**RE: APPROVAL WITH MODIFICATIONS
INVESTIGATION WORK PLAN FOR MATERIAL DISPOSAL AREA C, SOLID
WASTE MANAGEMENT UNIT 50-009, AT TECHNICAL AREA 50, REVISION 1
LOS ALAMOS NATIONAL LABORATORY, EPA ID #NM0890010515
HWB-LANL-03-005**

The New Mexico Environment Department (NMED) has reviewed the *Investigation Work Plan for Material Disposal Area C, Solid Waste Management Unit 50-009, at Technical Area 50, Revision 1* referenced by LA-UR-03-8201, ER2003-0696 and dated November 2003. NMED hereby approves the work plan with the modifications described in this letter. Modifications to the work plan and Historical Investigation Report (HIR) must be submitted as revisions to the work plan with redline strikeout of all edits. If the Permittees fail to implement the modifications, NMED will automatically rescind this approval.

Figure 3. Locations of pits and shafts at MDA C

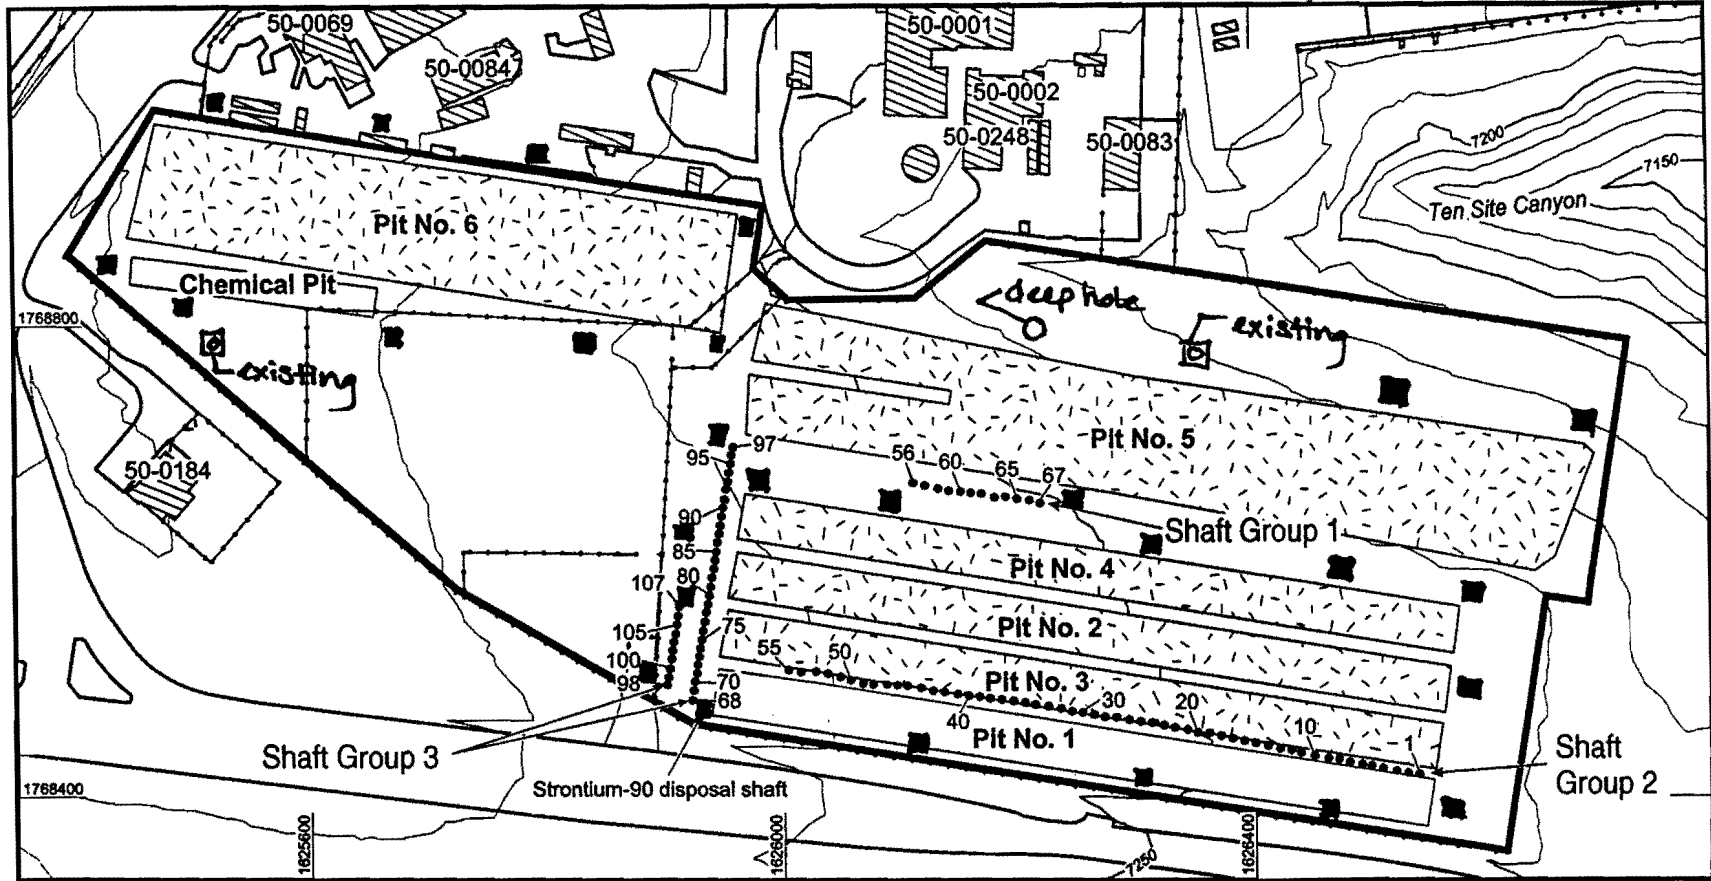
A) Borehole Locations: 33 boreholes total: 4 horizontal borings advanced beneath Pits 1-4 either beneath the long axes of the pits or at 150 ft intervals perpendicular to the long axes of the pits; the horizontal borings must be drilled at depths of approximately 30 feet bgs, this will correspond to ~ 5 ft below the estimated depth of the Pits; 28 vertical borings to 25 ft below the deepest detected contamination in accordance with Section IV.C.3.c.iii of the Order; one boring advanced to approximately 800 feet bgs to evaluate for the presence of vapor-phase contamination and intermediate perched groundwater. (See attached map for vertical borehole locations)

The boreholes must be drilled within 10 ft of the nearest known location/feature and as close to the proposed location as possible. If access to a location is impossible because of the presence of utilities or structures, or other obstacles, arrangements must be made to drill as close as possible to the proposed location. See attached map for vertical boring locations (based on Figure 3 of the work plan).

The size of the site alone warrants more than 14 boreholes to characterize contamination and define extent. The combined width of Pits 1-4 is approximately 200-ft. The length of these pits is approximately 550 ft-600 ft. Pit 5 is approximately 600 ft long and 100 ft wide. Pit 6 is approximately 550 ft long and 100 ft wide. As a reminder, Section IV.C.3.c.iii of the Order requires that boreholes be advanced directly adjacent to the down-slope end of each pit, at the lowest base elevation point of each disposal pit, at the corners of each disposal pit, at 100-ft intervals along the sides of disposal pits 1-6, at 70-ft intervals along the sides of the chemical pit, at the ends of each shaft row, at 50-ft intervals along each shaft row, and adjacent to the locations of the strontium-90 disposal shaft. NMED estimates that this could be as many as 50 boreholes. However, data provided by the Permittees suggests that 33 borings in the locations shown on the attached map may be adequate.
